Design Advisory Board (DAB) Board Agenda

Design Advisory Board (DAB) Project Review

DATE: February 26, 2024
PROJECT NAME: 1525 SPRUCE ST
CASE NO.: LUR2023-00037
ADDRESS: 1525 Spruce St
DESCRIPTION: Site Review Amendment to convert an existing building into six attached dwelling units. The site is part of an existing PUD (#P-82-20).
APPLICANT: Jim Bray, Bray Architecture
CASE MANAGER: Alison Blaine

1 ARCHITECTURAL SITE PLAN & OPEN SPACE

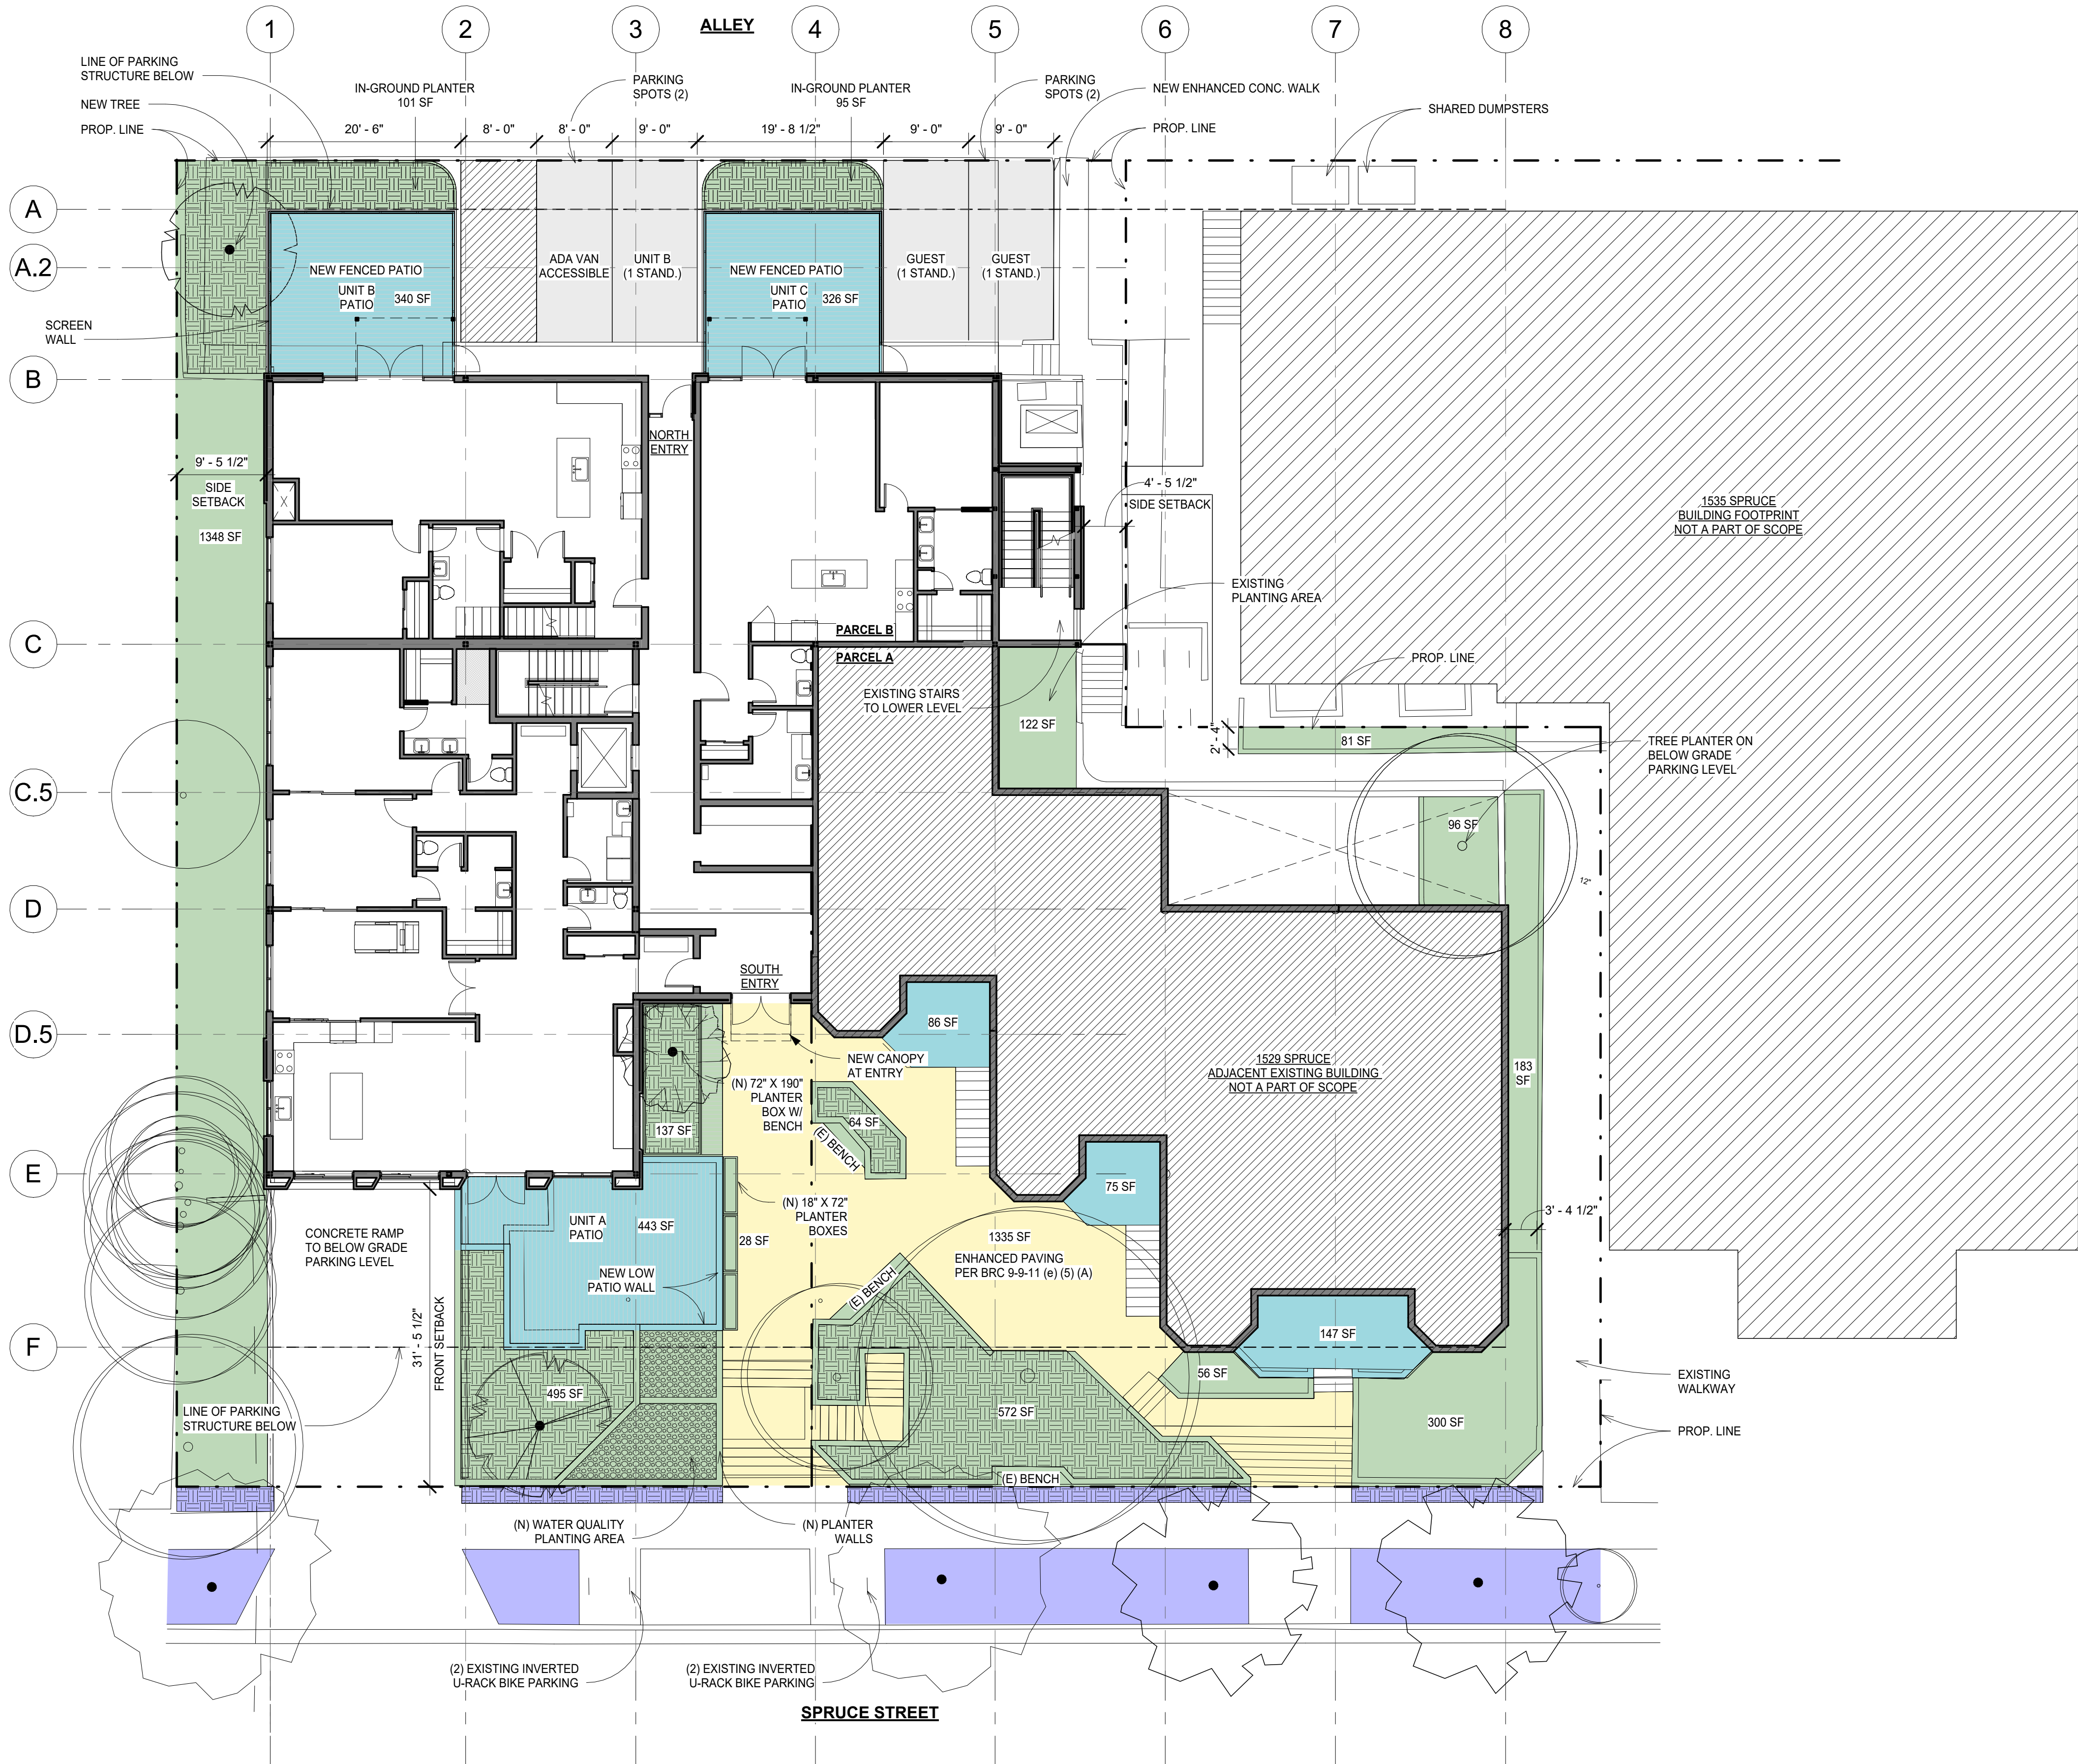
APPLICANT SELF-EVALUATION <i>Describe how the projects meets the criteria</i>	STAFF REVIEW				
	Compliance				Staff Comment
Open space is being made more usable by the inhabitants with the added patios and balconies.	S	PS	NS	N/A	The project includes new, additional private openspace areas to meet the needs of the residential use.
	<input checked="" type="checkbox"/>	<input type="checkbox"/>	<input type="checkbox"/>	<input type="checkbox"/>

APPLICANT SELF-EVALUATION <i>Describe how the projects meets the criteria</i>	STAFF REVIEW				
	Compliance				Staff Comment
Added alley landscaping is now screening parking.	S <input type="checkbox"/>	PS <input checked="" type="checkbox"/>	NS <input type="checkbox"/>	N/A <input type="checkbox"/>	The alley includes newly introduced landscape buffer areas. The transformer is recessed away from the alley and hidden from view. The below grade parking is accessed thru the existing location along Spruce St. The west elevation where the parking structure has exposed structural columns and ventilation areas that are not screened. The landscape area along this area could include vegetative screening or architectural elements.

EXISTING MECHANICAL VISIBILITY FROM ACROSS SPRUCE STREET

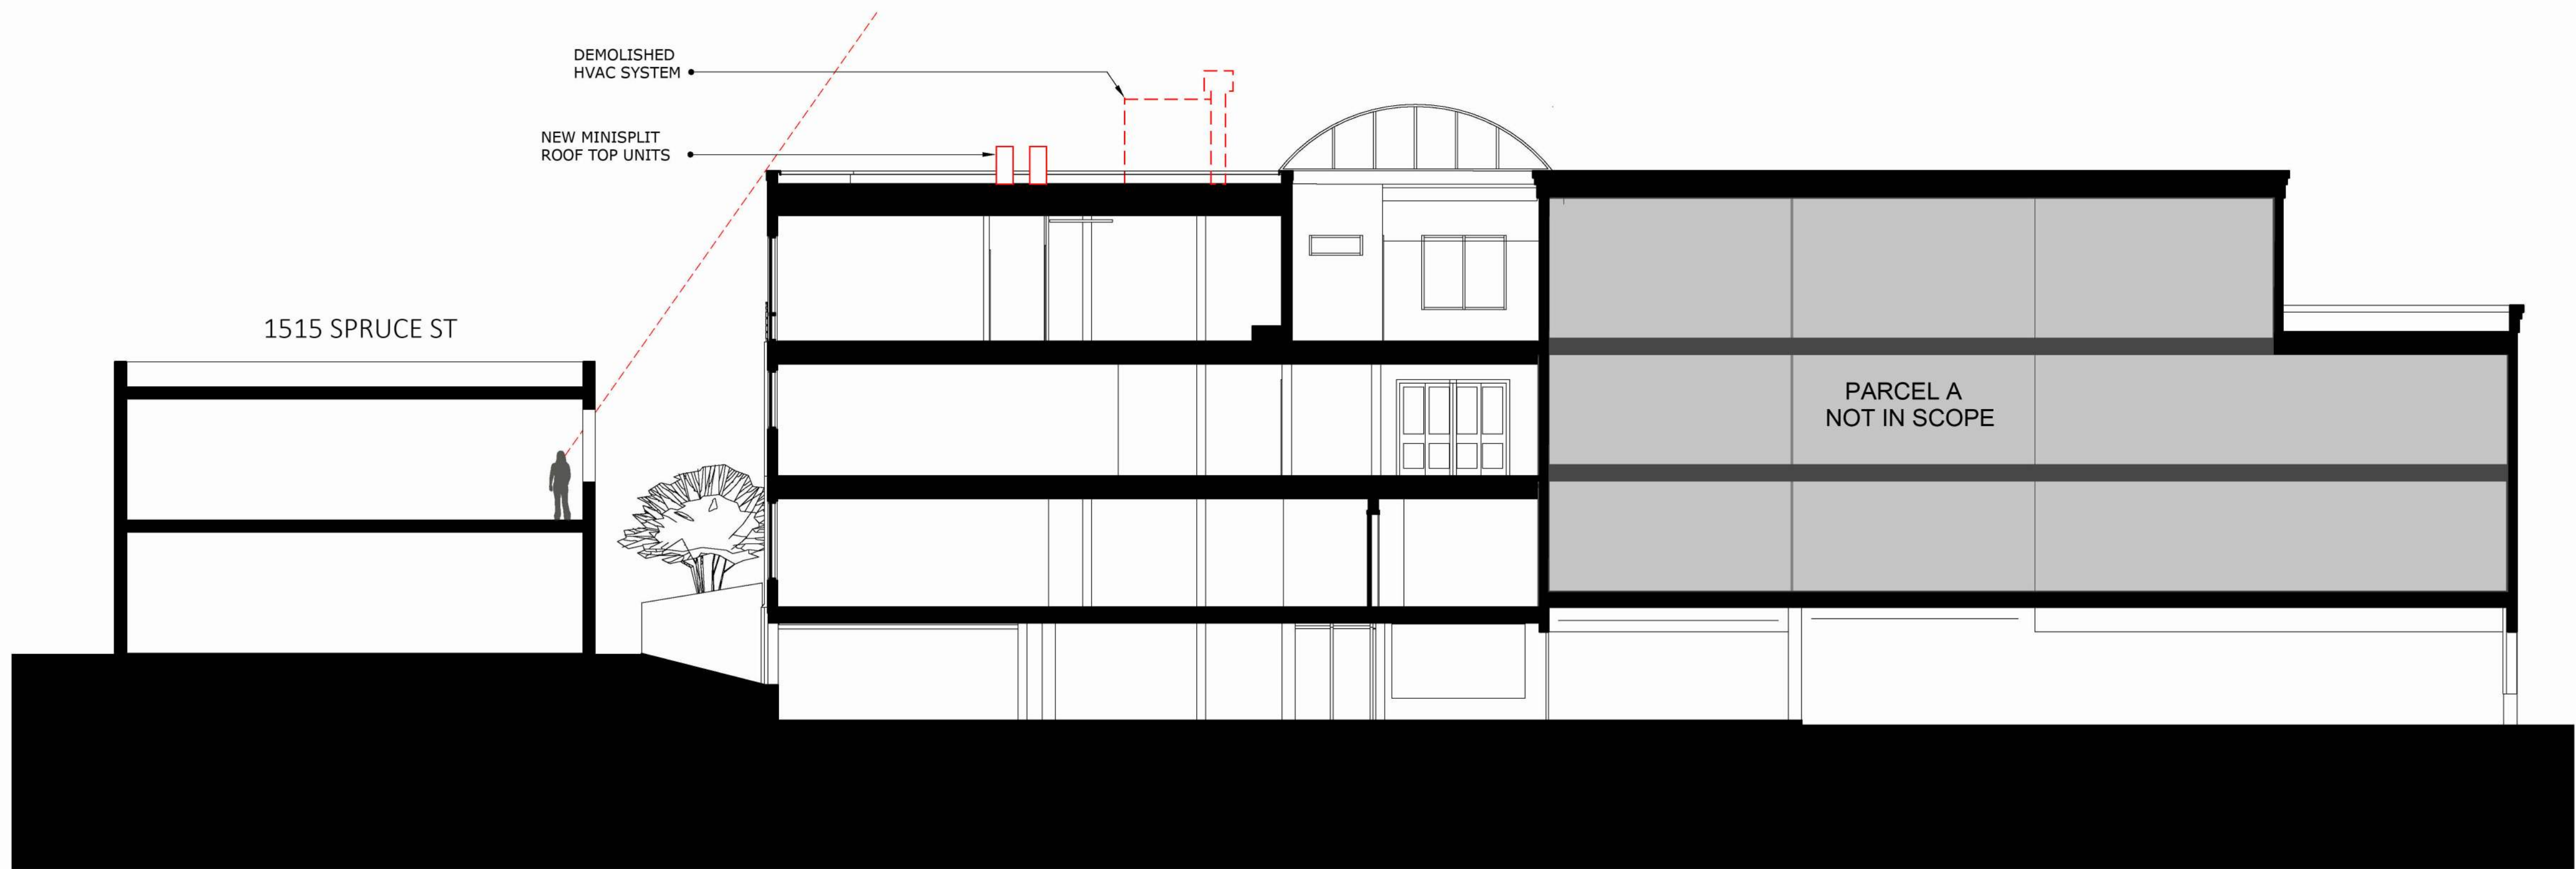
APPLICANT SELF-EVALUATION <i>Describe how the projects meets the criteria</i>	STAFF REVIEW				
	Compliance			Staff Comment	
The change in mechanical from a much larger RTU to smaller units will further reduce any visibility to mechanical on the roof.	S	PS	NS	N/A	The project will need to meet the code requirements for rooftop screening per 9-7-7(a)(4) “All mechanical equipment is screened from view, regardless of the height of the building, unless in the opinion of the city manager such screening conflicts with the function of the mechanical equipment.” The roof plan preliminarily indicates the screening footprint would be minimal and the placement of the PV array will not be affected by any shadow cast. Mechanical screening will be reviewed for conformance by planning staff during the final site review submittal.
	<input type="checkbox"/>	<input type="checkbox"/>	<input checked="" type="checkbox"/>	<input type="checkbox"/>
